Regarding Development Plan Application # 201504270021

Thank you for your letter summarizing the City's Departmental review of our development plan application for the Broadway and Park Apartment Homes proposed in Grove City's town center. Our responses to the comments provided by the various City Departments are as follows:

BROADWAY & PARK APARTMENT HOMES
Grove City, Ohio

DEVELOPMENT PLANS

**BROADWAY & PARK
APARTMENT HOMES**
GROVE CITY, OH

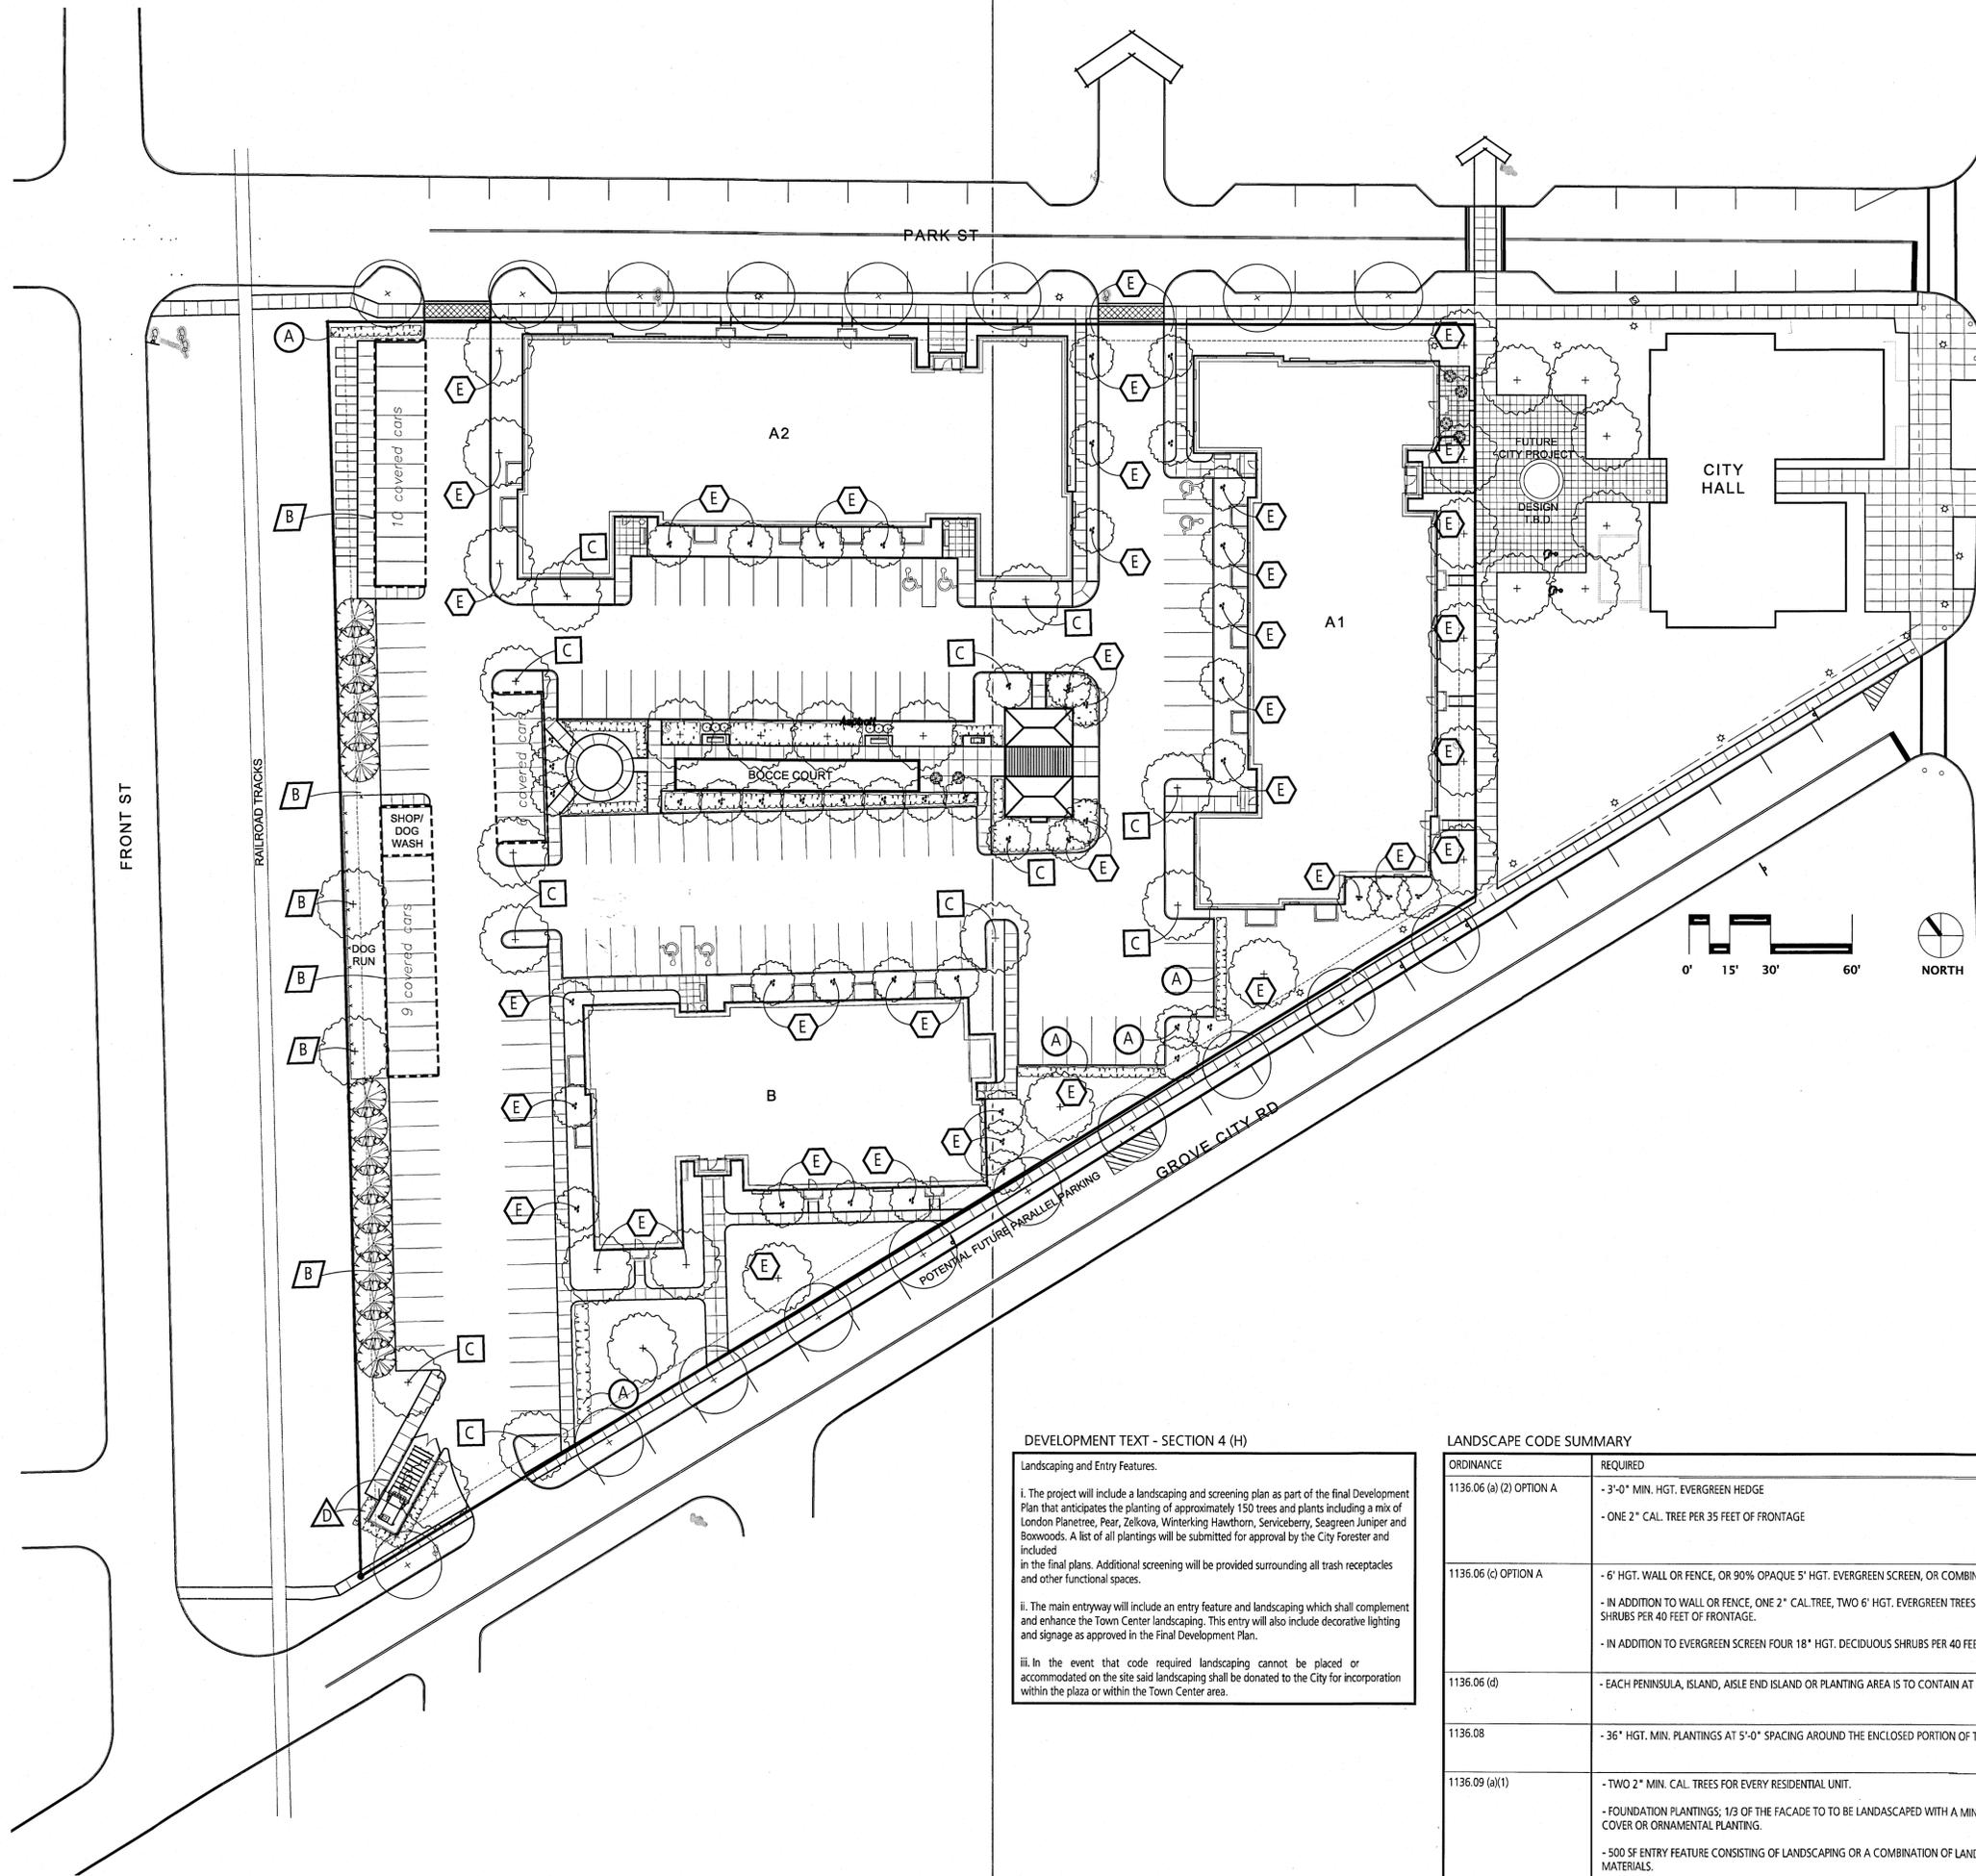
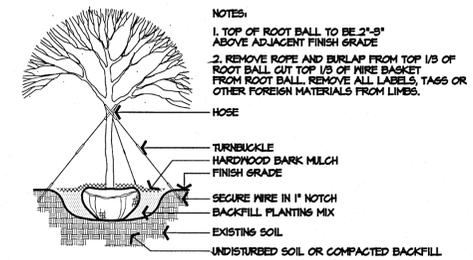
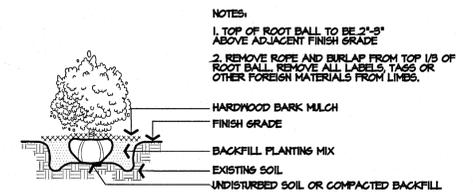
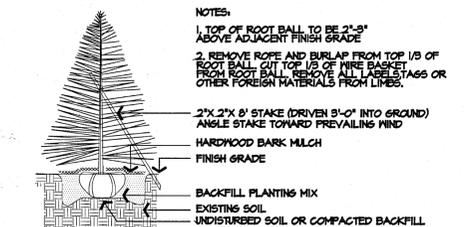
18. A landscape plan should be submitted, meeting the requirements of chapter 1136 and the proposed zoning and development standards text (C-29-15). The plan should include:

- e) Tree Planting Typical including a note stating 50% removal of burlap and wire cage from rootball of trees (1136.09(d))

RESPONSE: A 3' minimum height, continuous evergreen hedge and four 2" minimum caliper deciduous trees will be provided for 125' of frontage. A combination of evergreen trees and fencing as part of the carport design will provide screening along the western property line along the railroad tracks. 12 2' caliper deciduous trees will be planted in the parking area in landscape islands, aisle ends and peninsulas. Plantings will be provided to meet the PUD text. Details will be provided for approval with final site permit drawings.

RESPONSE: Typical tree planting detail will be provided to meet this requirement. Details will be provided for approval with final site permit drawings.

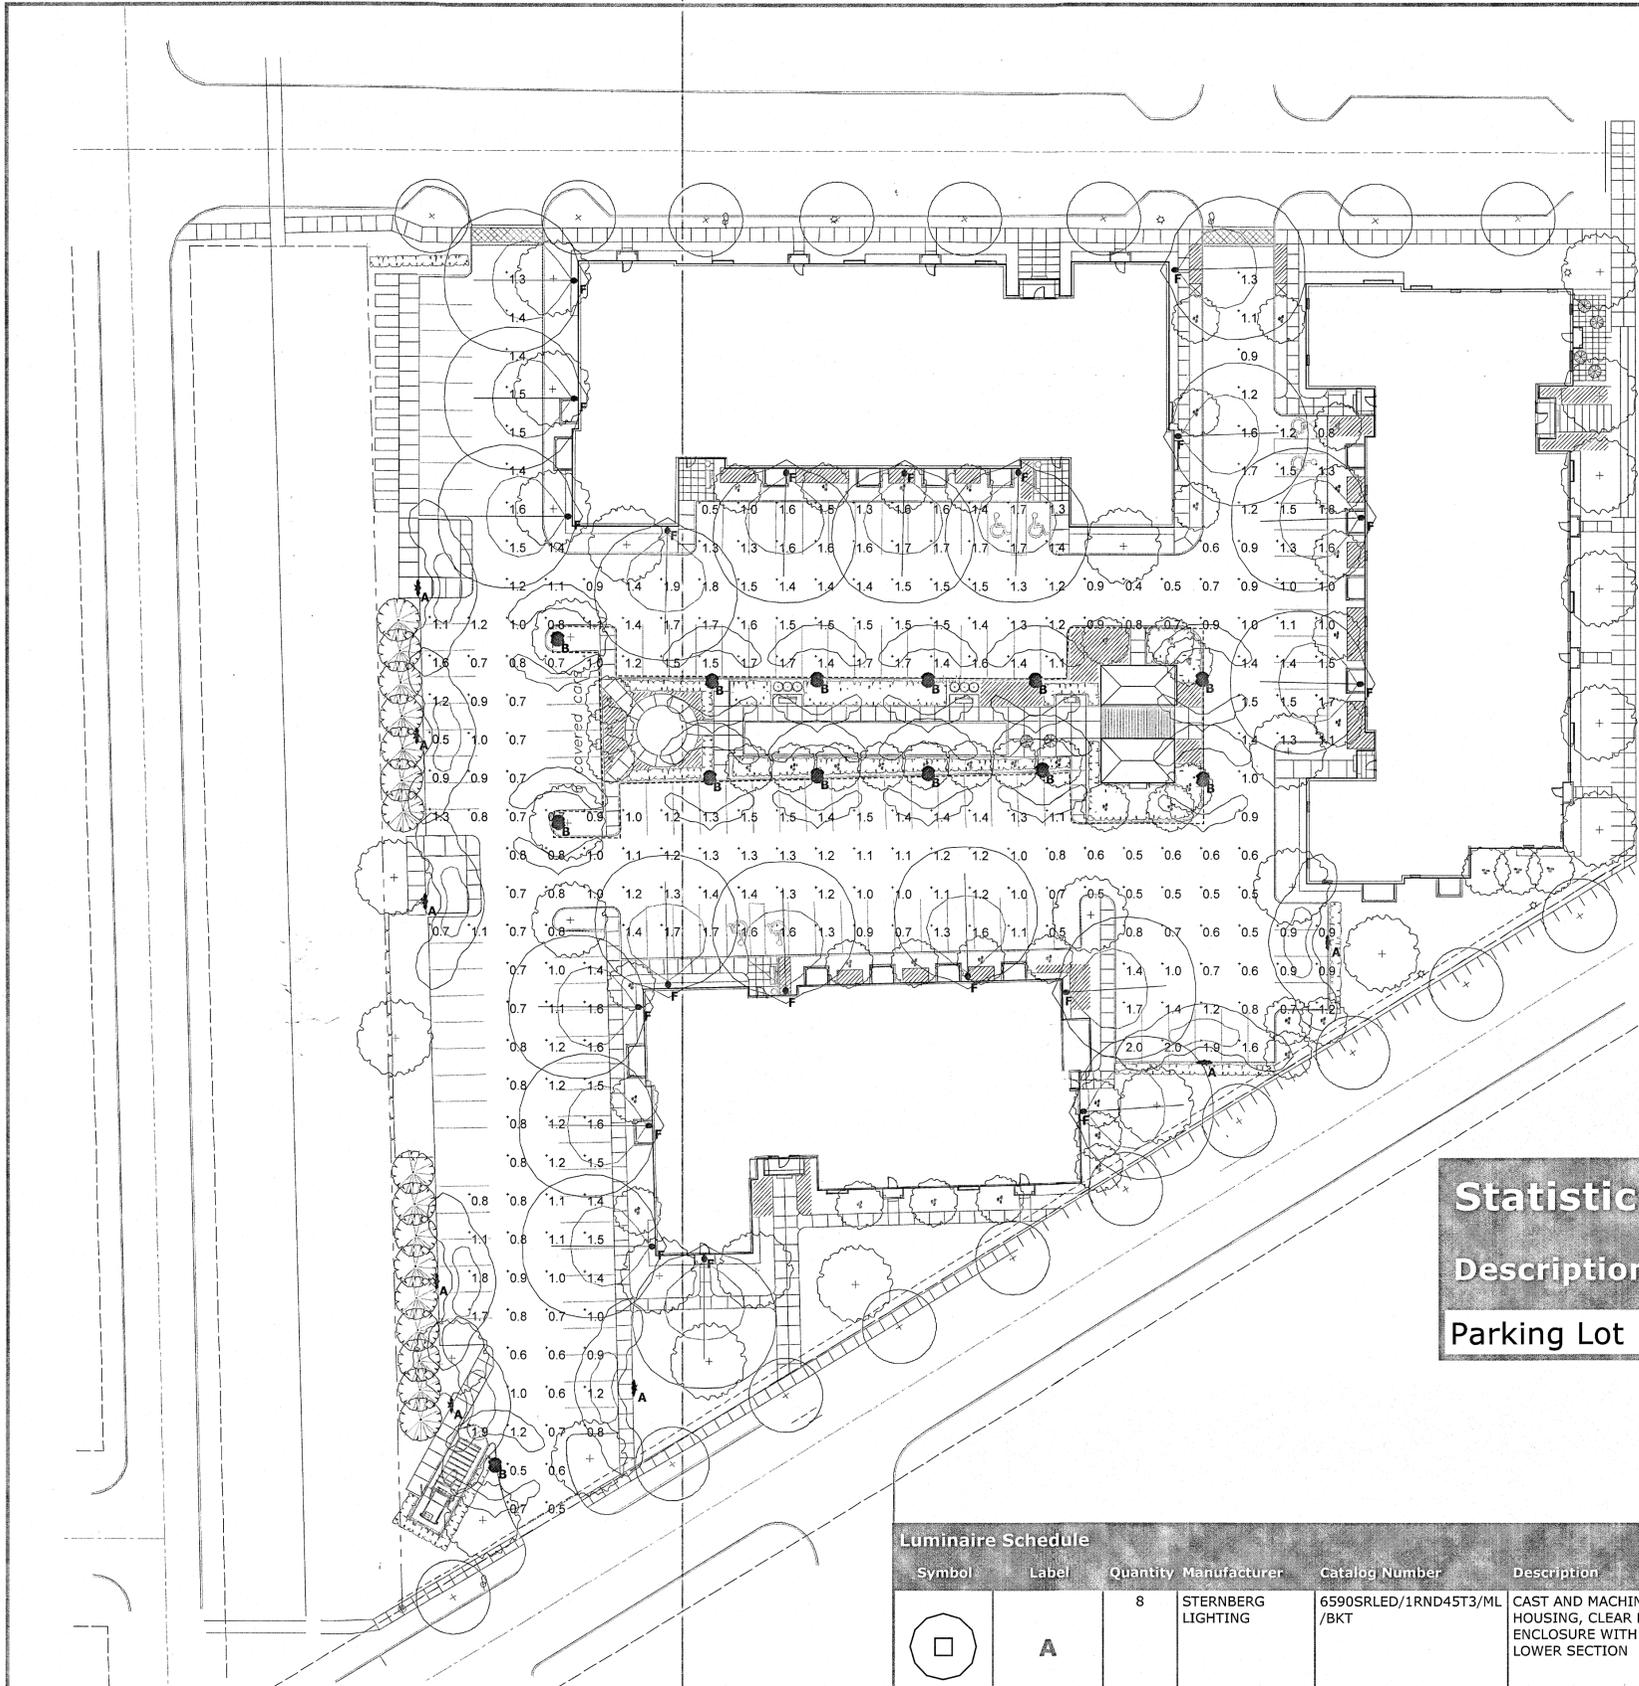
4. A lighting plan should be submitted with details for site and exterior building fixtures. Fixtures should be decorative and match the character of lighting in the Town Center, as required in section 4(k) of the proposed Zoning and Development Standards Text (C-29-15).

24. Make sure there is lighting at the rear of the building; couldn't see any on the elevation drawings.

RESPONSE: A lighting plan has been included with this submittal.

RESPONSE: Light shall be provided at the rear of the buildings per the attached lighting plan. Additionally, there shall be an exterior light fixture at each doorway and porch. Low voltage landscape lighting shall be installed by the developer as well to highlight the decorative landscape features and provide accent lighting to the buildings.
